**Re:           ADDENDUM #2  
              Spruce Avenue Reconstruction  
              Contract No. 10-25, File No. 570.02-457**

**Re:           ADDENDUM #1  
              Spruce Avenue Reconstruction  
              Contract No. 10-25, File No. 570.02-457**

ROAD SETTLEMENT & BIN WALL STABILITY  
 SPRUCE AVENUE  
 BURLINGTON

DRAWING NO. 2

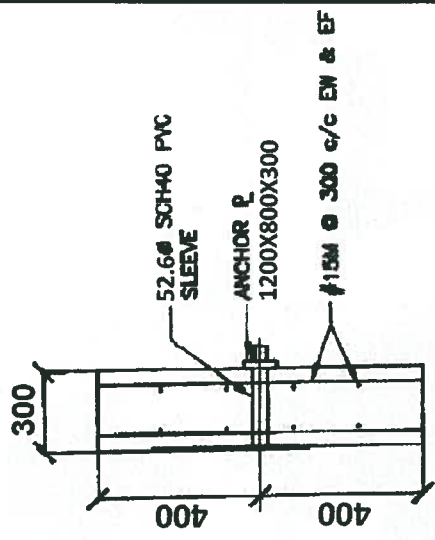
This item, M01001, as described below, is to provide enhanced stability of the existing bin-wall at the Appleby Creek culvert. Localized settlement has occurred adjacent to the retaining wall.

- Three dead man anchors with tiebacks shall be installed through the existing bin-wall as shown on drawing Nos. 1 and 2, as attached. The top of the dead man anchors shall be installed 0.4m below finished road grades. Backfill materials around the dead man anchors shall be compacted to 100% standard proctor maximum dry density (SPMDD).
- In the area where settlement has occurred, the existing fill shall be removed to 0.6m below finished road grades, and re-compacted in place. The backfill shall be placed in 300mm thick loose lifts and compacted to 98% SPMDD.
- This re-compaction of the settlement area will require the removal and replacement of approximately 10m<sup>2</sup> of sidewalk. The sidewalk at this location is reinforced concrete integral with the adjacent parapet wall. Reinstatement will require doweling and reinforcing as required.
